Subject: MHI's Response to US-APWR DCD RAI No.468-3360 Revision 1

Responses to Request for Additional Information No. 467-3609
Revision 1

US-APWR Design Certification

RAI NO.: 468-3360 REVISION 1
SRP SECTION: 09.05.04 – Emergency Diesel Engine Fuel Oil Storage and Transfer System
APPLICATION SECTION: TIER 2 9.5.4
DATE OF RAI ISSUE: 10/6/2009

FIGURE 9.5.4-1 GAS TURBINE GENERATOR FUEL OIL STORAGE AND TRANSFER SYSTEM SCHEMATIC DIAGRAM.

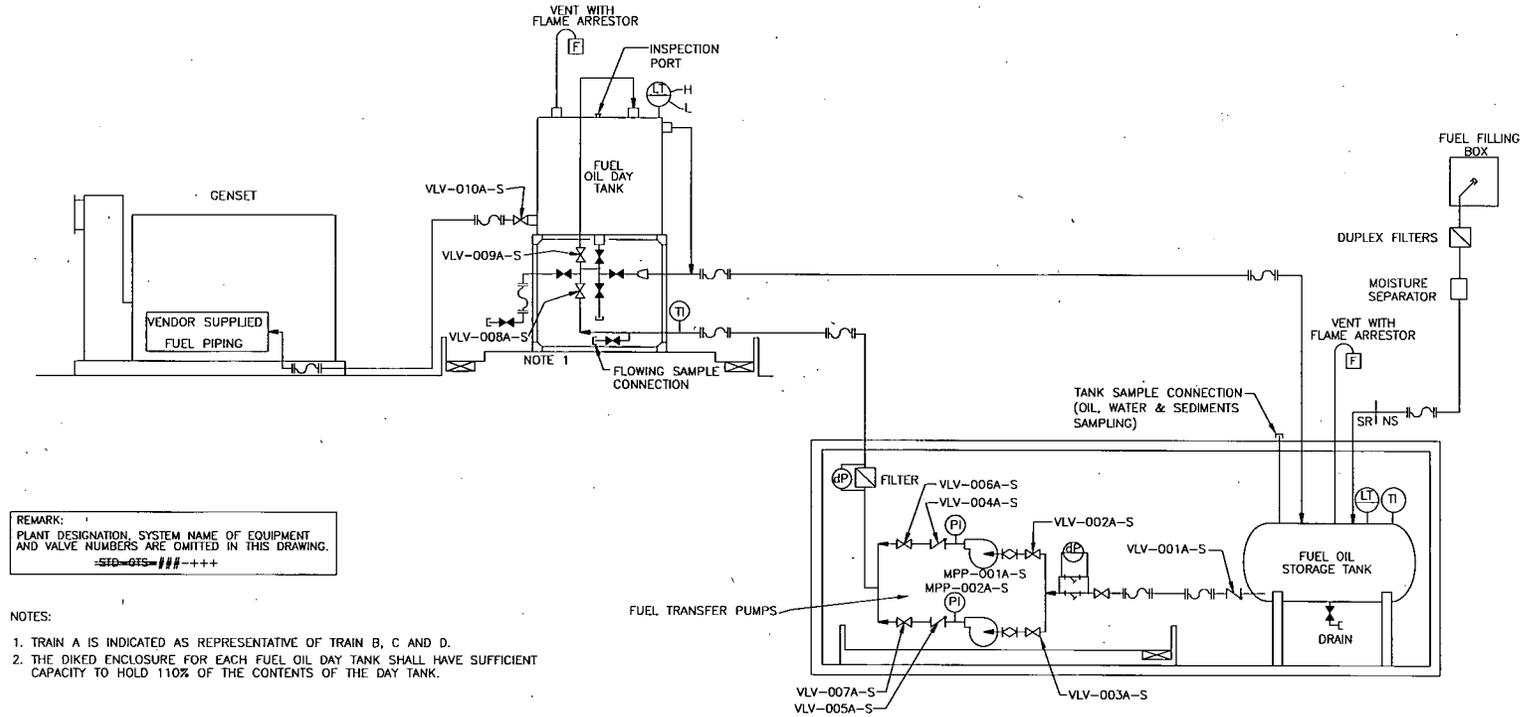
- Section 6.2.4 – The response (top of page 9.5.4-16) states that “fill and sample connections are located at grade elevation...”. However the revised Figure 9.5.4-1 shows the sample connection within the tank enclosure. Revise the response or figure to be consistent. Also, the 6.2.5 response states that “The fill line is above grade.”

- Section 6.2.5 – The response states that “fill line has a strainer located downstream of the isolation valve...” The revised Figure 9.5.4-1 identifies this as a duplex filter which is the ANSI/ANS requirement. Revise the response to change “strainer” to “filter”.

- Section 6.3.3.1 – The response notes that “pressure indicators and a differential pressure alarm on the fuel oil transfer pump discharge strainers are provided.” This should refer to the fuel oil transfer pump suction strainers. The response should be revised to be consistent with Figure 9.5.4-1, etc.

Supplement to Question No. 09.05.04-11 (RAI 9.5.4-06; RAI Set No. SBPB 318-2227, Rev. 1; MHI Ref: UAP-HF-09292, dated 6/9/09): As noted in the discussion for Question 09.05.04-10, the termination of the sample connection is not consistently described by MHI. In addition, this response states that the sample is from the top of the tank and measures sediment and water. MHI should describe how the sample will be removed against gravity from the top of the tank and explain how a sample from the top will monitor sediment and water, both of which are most likely to be on the bottom of the tank.

Supplement to Question No. 09.05.04-22 (RAI 9.5.4-17; RAI Set No. SBPB 318-2227 Rev. 1; MHI Ref: UAP-HF-09292, dated 6/9/09): While the NRC recognizes that Figure 9.5.4-1 is a schematic diagram, the revised drawing clearly indicates that the pump suction connection on the tank is at the top of the tank and extends down internally from the top of the tank to the bottom of the tank. This diagram leaves in question the means of ensuring a flooded suction for the pumps. The check valve shown on the revised figure may maintain a flooded suction once the suction line is filled, but check valves can leak and create an air gap that could prevent the oil transfer function. The design should provide assurance that adequate suction pressure will be maintained.

See attached markup for revision to Figure 9.5.4-1 (Attachment A). DCD Section 9.5.4.2.2.1, revised with new paragraphs added after the third paragraph, as revised per Question 44 "Impact on DCD".

Figure 9.5.4-1 is a sketch, not meant to show the actual elevations of the equipment; however this figure is being revised for clarity as shown in the attached drawing. As addressed in RAI No. 09.05.04-08, these pumps are located in the storage tank vault, below the tank outlet, and are therefore able to operate with flooded suction.

The fuel oil transfer pumps are located in the fuel oil storage tanks vaults, as shown in the updated Figure 9.5.4-1, such that sufficient net positive suction head is available under all design conditions, including pump runout. The available NPSH is calculated based on all pump design operating conditions and is incorporated as part of the oil transfer pumps specifications to provide assurance from the pump vendor to properly design and fabricate the oil transfer pumps for their intended purpose. Once a vendor has been selected, the specific parameters for the pumps, including available NPSH, will be confirmed based on vendor documents.

Figure 9.5.4-1 will be revised to indicate that the pump suction connection is at the side of the tank at 6 inches from the tank bottom per DCD Section 9.5.4.2.2 this will assure that adequate suction pressure will be maintained.

Figure 9.5.4-1 will be updated as shown in the attached markup (see Attachment A).
